Hydro One Networks Inc.

EB-2007-0050 – Hydro One Networks' Section 92 Bruce - Milton Transmission Reinforcement Application – Hydro One Networks' Response to Interrogatory Questions from Pollution Probe List 4 and List 5

Pollution Probe INTERROGATORY #24 List 4

Figure 1

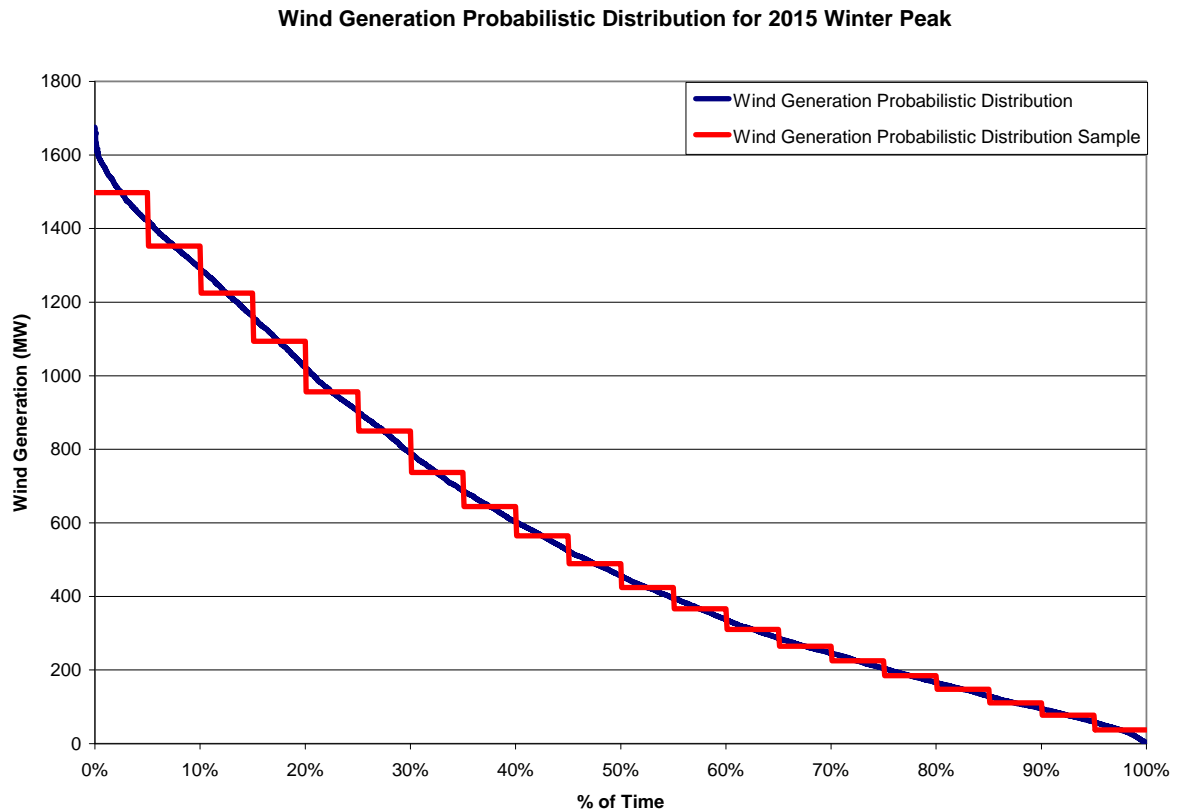
- c) Please provide the estimates of locked-in energy for the finest level of temporal detail calculated.
- d) Please provide the “probabilistic distributions” for both wind and nuclear generation that was developed as part of the response.

d) The Model used to determine the amount of undelivered energy considers probabilistic distributions for wind and nuclear generation for each year of study. The wind generation is modeled for each of the eight time periods discussed in the above-referenced response. The nuclear generation is modeled for two time periods (winter/summer and shoulder) and three different states at Bruce NGS (zero, one and two units removed for refurbishment). There are 266 probabilistic distributions representing nuclear and wind generation for the entire study period between 2012 and 2030. All of the distributions are similar; therefore only one wind generation probabilistic distribution and one nuclear generation probabilistic distribution are shown in Figures 1 and 2 below. The Model cannot process the entire distribution and needs to sample it in order to conduct its calculations. The sampled distribution is shown by the red line that moves stepwise. The Model uses an average sampling method and does not take into account the peak values (making any calculations conservative ones, such as those in the response to the referenced interrogatory).

Figure 3

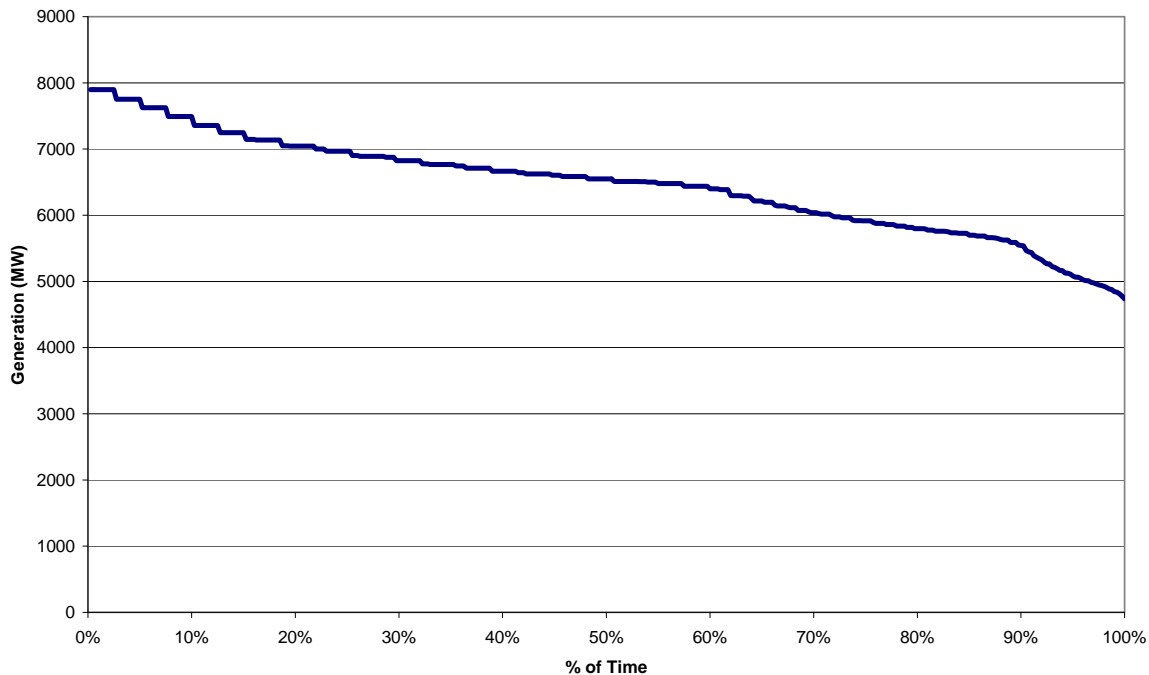
- e) Please provide the “probabilistic distribution of total generation in the Bruce area” that was developed as part of the response.
- f) Please provide the “transfer-capability probability distributions” that were developed as part of the response.

e) There are 24 total generation cases modeled for each year of study. This totals 456 distributions for the study period. Again, because all of the distributions are similar, only one example of this distribution is shown in Figure 3 below.
